UNITED STATES PATENT AND TRADEMARK OFFICE

APPLICATION NO.	FILING DATE	FIRST NAMED INVENTOR	ATTORNEY DOCKET NO.	CONFIRMATION NO.
10/634,235	08/05/2003	Peter Bernhardt	1-24671	6403

Office Action Summary

DETAILED ACTION

REPLACEMENT SHEET

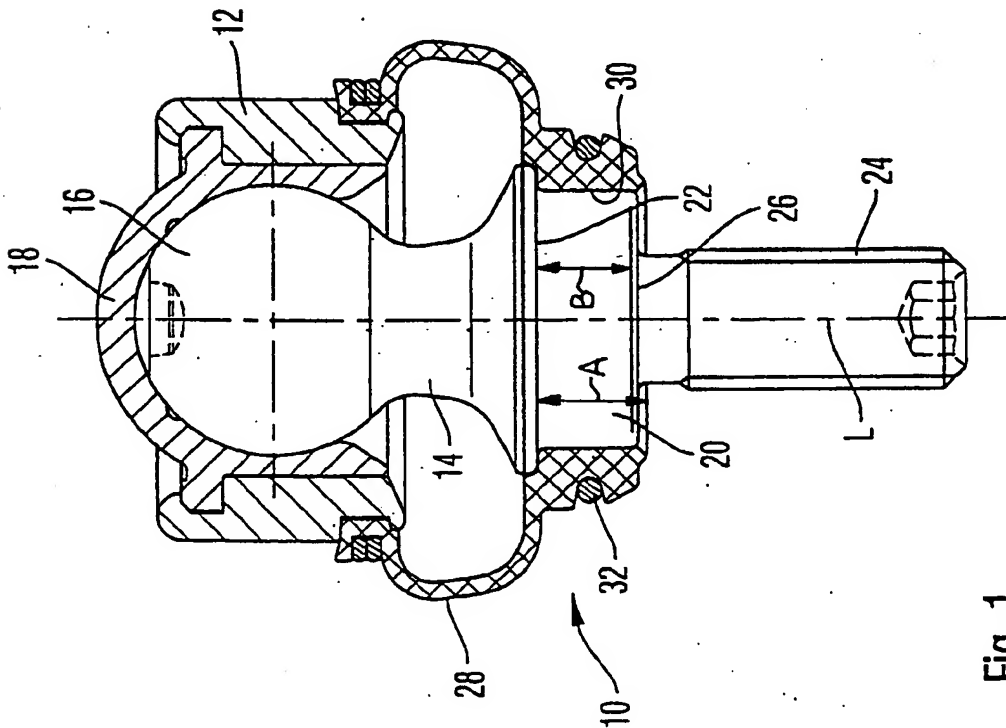
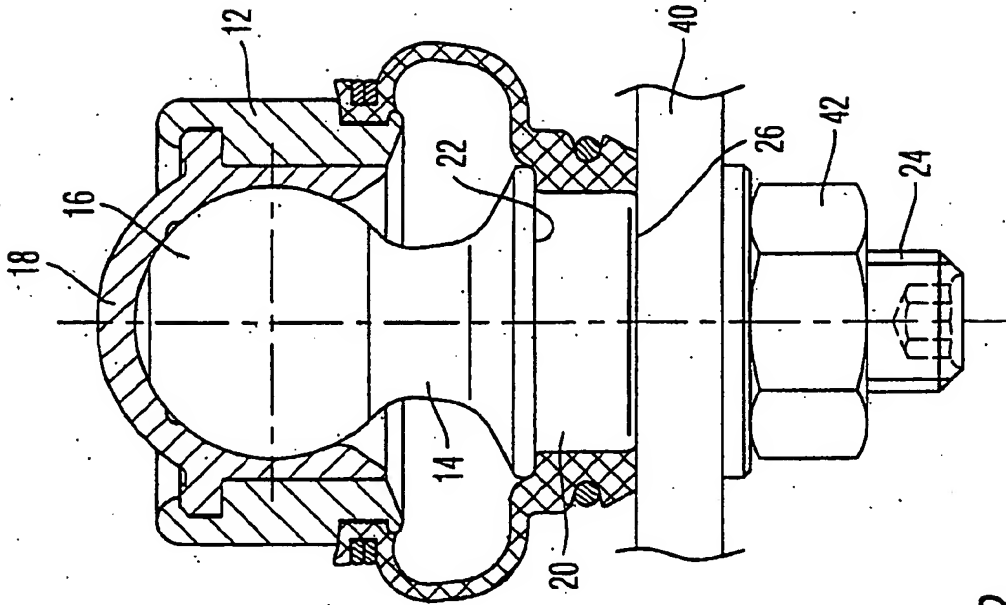
The drawings were received on May 19, 2005. These drawings are not acceptable.

The drawings are objected to under 37 CFR 1.83(a) because they fail to show the height B measured between the plate (*vis.* plane) at which it contacts the shoulder 2 and its outer end as amended in the paragraph beginning on page 3, line 10 as described in the specification. Any structural detail that is essential for a proper understanding of the disclosed invention should be shown in the drawing. MPEP § 608.02(d). Applicant should note that the height B as presented in the replacement drawings is between the plane at which it contacts the shoulder and some extra line, which is not the outer end of the shoulder 20.

The drawings are objected to because the line unreferenced in Figures 1 and 2 above the outer end of the shoulder 20 makes unclear what it represents. The extra line appears to be a draftsman's error and needs to be deleted. Further, the cross

hatching of the sealing bellows 28 is incorrect. Corrected drawing sheets in compliance with 37 CFR 1.121(d) are required in reply to the Office action to avoid abandonment of the application. See MPEP 608.02(e).
